Attachment –

The NRC staff's review of Sam Miranda's 10 CFR §2.206 petition of November 15, 2016:

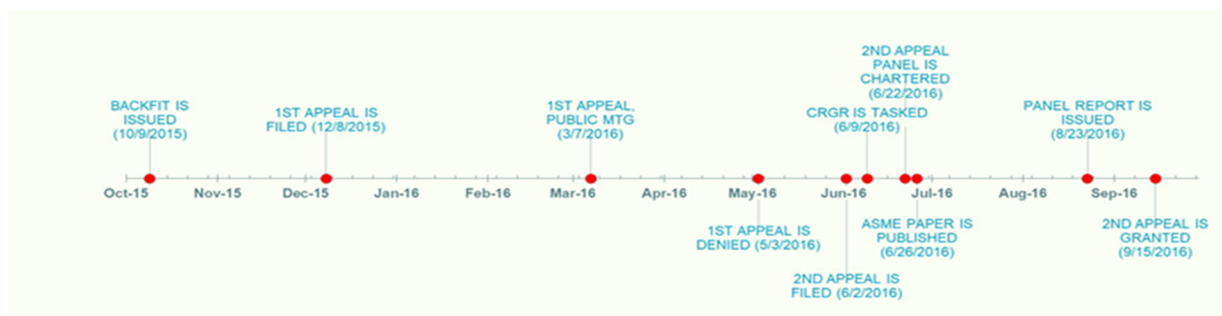
The BARP's purpose is stated on page 2 of its report [5]. It is to, *provide information and recommendations to support the EDO's decision on the appeal*. So, the BARP is not really a review panel. It's more of a Backfit Approval & Reversal Panel. This can be seen in the following timeline of events [17].

Note that it took the NRR appeal panel almost five months to consider, and ultimately deny Exelon's first appeal. It took the EDO only one week to issue a tasking memorandum, to the CRGR, to review the *lessons learned* from the backfit appeal, and develop a plan to apply them. Two weeks later, the EDO chartered an appeal panel of five (i.e., the BARP) to *provide information and recommendations* [5] to support his decision to grant Exelon's second appeal. One of the BARP's five panel members is also the chairman of the CRGR. The NRC did nothing to resolve the conflict of interest, even after an objection from the petitioner.

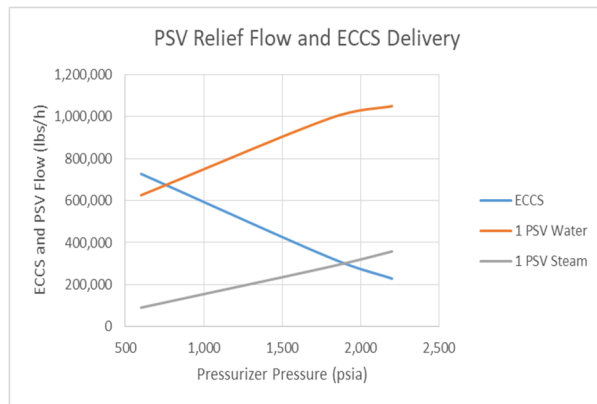
The following figure, copied from [2], shows that the water relief rate through one open PSV will be greater than one million lbs/h. The same curve could also be interpreted as representing the water leak rate through the three seated PSVs. The curve is based upon the calculated relief rate for saturated water. The calculated relief rate for subcooled water would be much higher. If the minimum expected discharge water temperature is as low as 590 °F, as claimed by Exelon [7], then the calculated water relief, or leak rate would be greater than 1.7 million lbs/h.

A leak rate that exceeds the ability of the normal makeup systems to replace the lost water is defined as a LOCA. So, an IOECCS that occurs in the Byron and Braidwood plants will result in a LOCA, even if all the PSVs reseal, after having relieved water. Furthermore, Exelon does not explain how an unisolable leak rate that exceeds one million lbs/h could be deemed to be an acceptable outcome for an AOO, and the NRC staff doesn't ask.

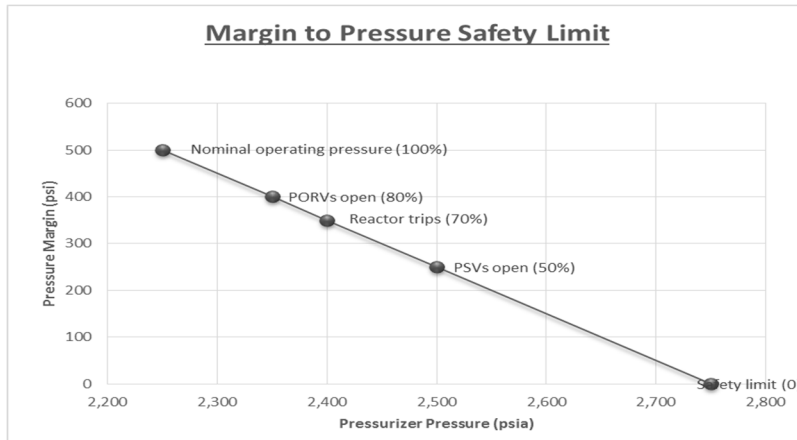
When the PORVs are applied, the margin of safety, to RCS overpressure is 400 psi (2750 psi minus 2350 psi). When the PSVs are applied, the margin of safety, to RCS overpressure is reduced to 250 psi (2750 psi minus 2500 psi). The margin of safety is thus reduced by 37.5%. For perspective, 150 psi is more than half the pressure that is developed inside the boiler of a steam locomotive. Note that the question has nothing to do with the valves' performance under steam or water relief conditions.

Exelon's plan to use PSVs, in lieu of PORVs, significantly reduces pressure safety margin, as depicted in the following figure.
